SITE PLAN REVIEW AND APPEARANCE BOARD

---STAFF REPORT---

MEETING DATE: February 24, 2016

ITEM: **One 10 Building** – Class III Site Plan Modification, Landscape Plan, Architectural Elevations and Waiver Request associated with interior and exterior renovations including enclosing the main lobby area, removal of stairs and installation of an elevator serving all floors, construction of a porch along SE 1st Avenue, and relocation of existing exterior dumpster enclosure areas. The porch along SE 1st Avenue will require a waiver to allow 5' where a minimum 8' porch depth is required.

Proposed Site Plan

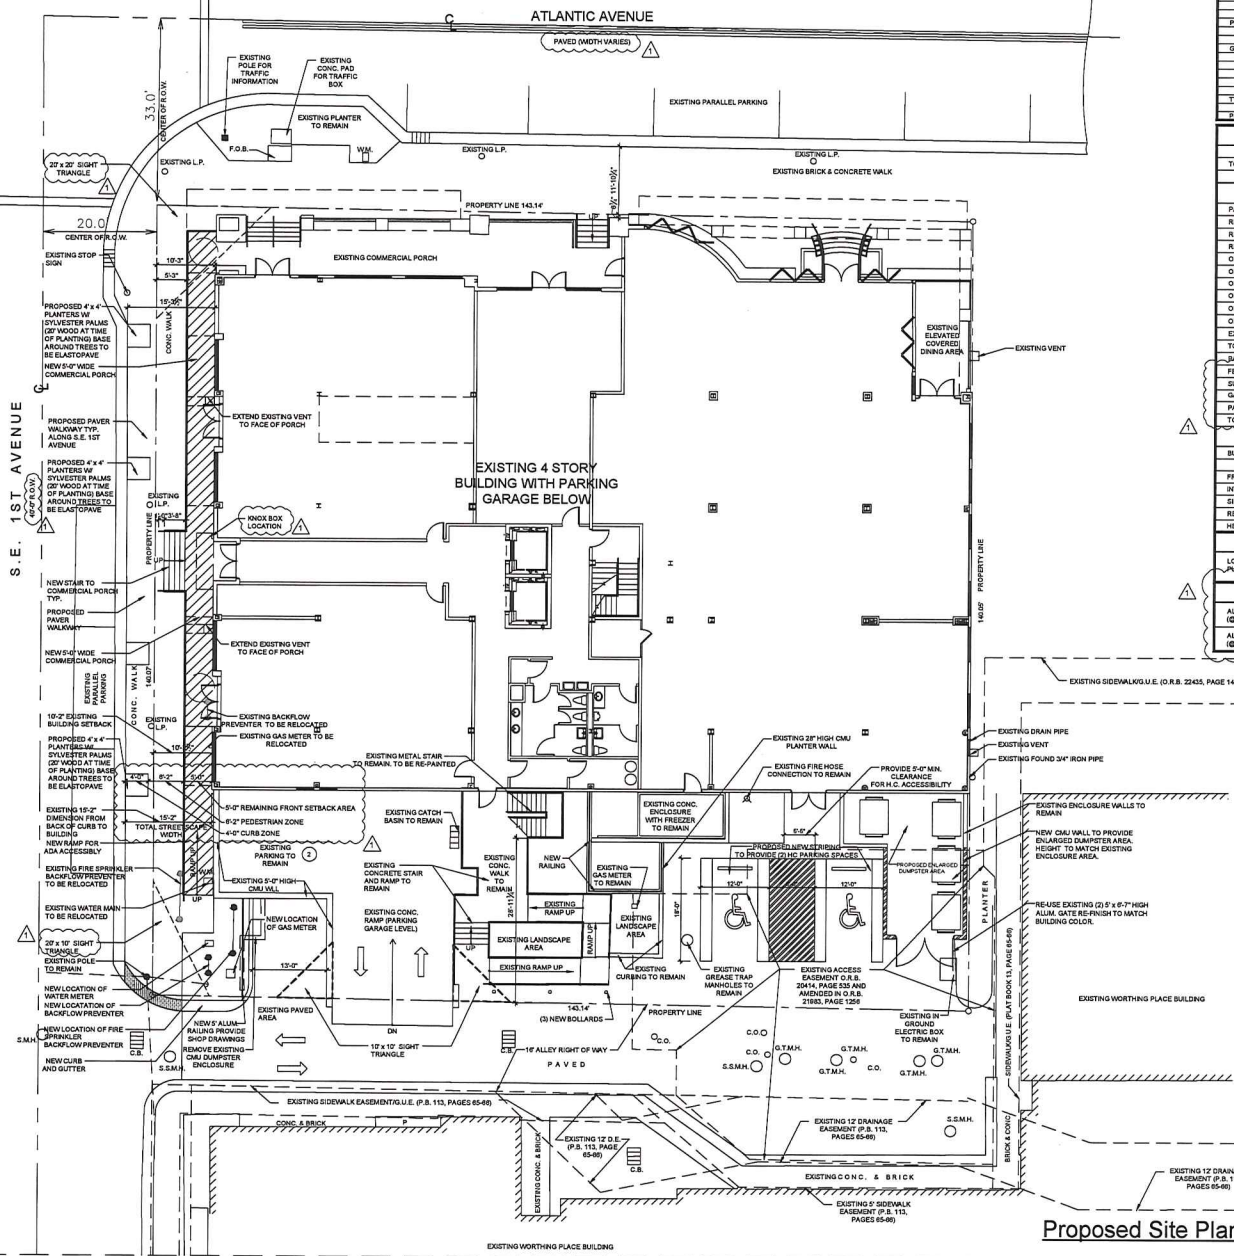
Pursuant to LDR Section 4.4.13(E)(4)(a) the porch is an open-air structure attached to a building forming a *covered entrance* large enough for comfortable use as an outdoor room. Table 4.4.13(E) provides the dimensional requirements for all elements contained in a porch as indicated in the chart below:

Table 4.4.13(E)	Dimensional Requirements		
Commercial Porches	Minimum Required	Maximum Allowed	Existing/Proposed
Building Setback	10 ft.	15 ft.	10'2"
Porch Depth	8 ft.	12 ft.	5 ft.
Porch Width	40% Facade	100% Facade	100%
Floor Elevation	0.5 ft.	4 ft.	3 ft.
Allowable Encroachment ¹	-	8 ft.	-

As indicated in the chart above, the One 10 Building meets all dimensional requirements for those elements contained in a commercial porch, with the exception of the depth, for which a waiver is requested. The waiver is analyzed in the "Waiver Analysis" section of this report.

The applicant has requested a waiver to LDR Section 4.4.13(E)(4)(a), which requires an 8' porch depth, whereas only a 5' porch depth is proposed. The following verbatim justification is given by the applicant to support the waiver request (*in italics*):

The City concurs with the applicant's request for the 5' porch depth, whereas a minimum 8' porch depth is required. Specifically, approval of the waiver shall not result in an inferior pedestrian experience because creation of the porch where one does not exist, actually creates a better pedestrian experience than what exists today. In addition, if the 8' porch depth was provided it would encroach into the required pedestrian clear zone and curb zone, which is specifically disallowed by code. There are no civic open spaces provided, thus this criteria is not applicable. Therefore, the request for the waiver substantially meets the standards of LDR Section 4.4.13(K)(8)(b)(2).

RECOMMENDATION: **Move Approval** of the Waiver Request, Class III Site Plan Modification, Landscape Plan and Architectural Elevations for One 10 Building, subject to conditions.

sheet title:
planting
plan

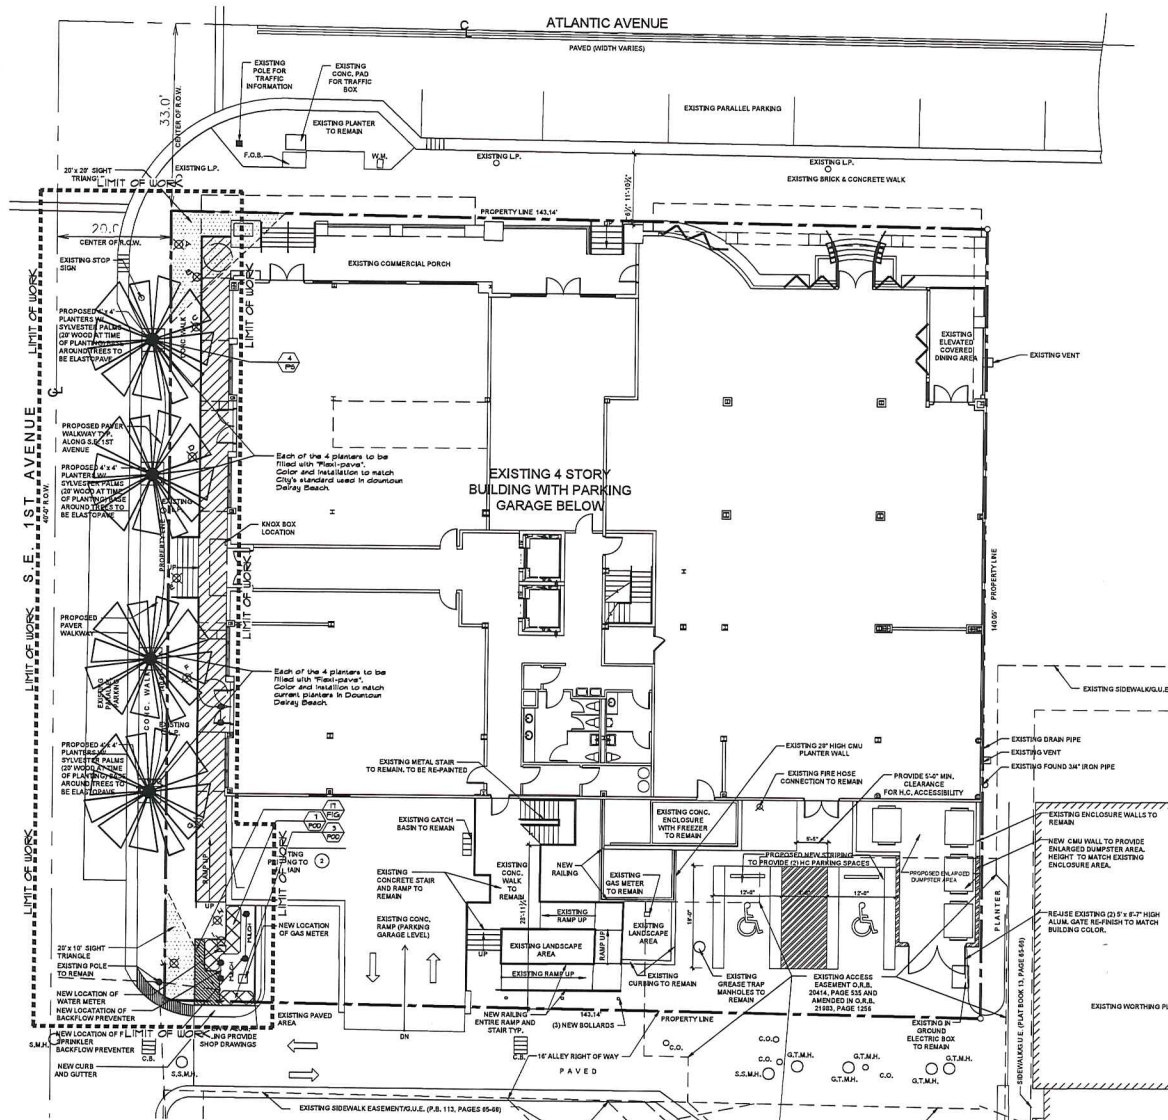
A landscape plan was submitted for review and has been evaluated by the City Senior Landscape Planner. The landscape plan provides streetscape material and calls for upgrading existing landscape islands. The landscape plan generally complies with LDR Section 4.6.16. However, this one technical item that need to be addressed and is listed below:

1. A Landscape Maintenance Agreement is required for the proposed plantings outside the property line. The signed agreement with the supporting exhibits must get executed by City Commission. A signed agreement has been received and will require City Commission approval, prior to building permit issuance.

Based upon the above and once the technical comment is addressed, the proposed landscape plan will be in compliance with the provisions of LDR Section 4.6.16.
